Planning & Development Consultants
63 York Road
Dun Laoghaire
Co. Dublin
www.brockmcclure.ie

**Additional Information Response for Planning Application by Cedarglade Ltd.
Main Street, Newcastle, Co. Dublin (Reg. Ref. SD21A/0311)**

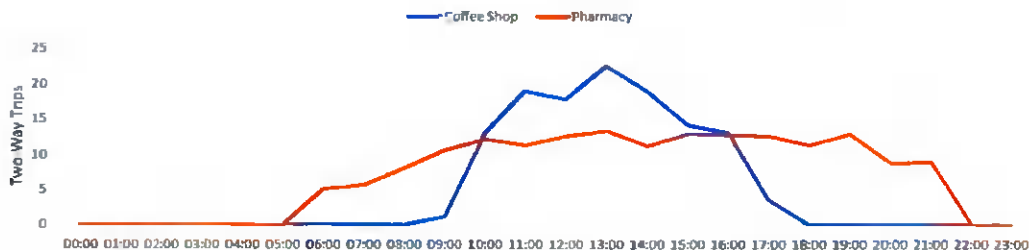
The Planning Authority has concerns that the proposed pharmacy use will result in a different dynamic than that created by a cafe /community centre, which was initially assessed in previous planning permission. The pharmacy is likely to generate additional deliveries and will generate 'quick-stop' journeys to collect medication. Having regard to the proposed change of use and the nature of the use, the applicant is requested to explore both these issues and submit revised proposals that demonstrate that considerations has been given to loading of deliveries and providing ease of access for quick collections from Main Street and confirm if on-street car parking can be provided. In this regard, the applicant should liaise with the Roads Department.

Response: We refer the Planning Authority to the attached details by MCA Architects that indicate The SuperValu car park layout has been revised to show a designated parking space for deliveries to the proposed pharmacy which can be accessed from the rear. There is no restricted access from SuerValu to the proposed pharmacy.

A TRICS trip generation exercise carried out by DBFL Consulting Engineers for a pharmacy and cafe indicates a higher peak demand for the café (this does not take into account dual trips at both potential land uses e.g. users going to the Supermarket and then the café or pharmacy).

We therefore submit the pharmacy would have a steadier flow of activity throughout the day, will not give rise to specific peak periods that may lead to congestion and can be easily serviced and access from the SuperValu car park.
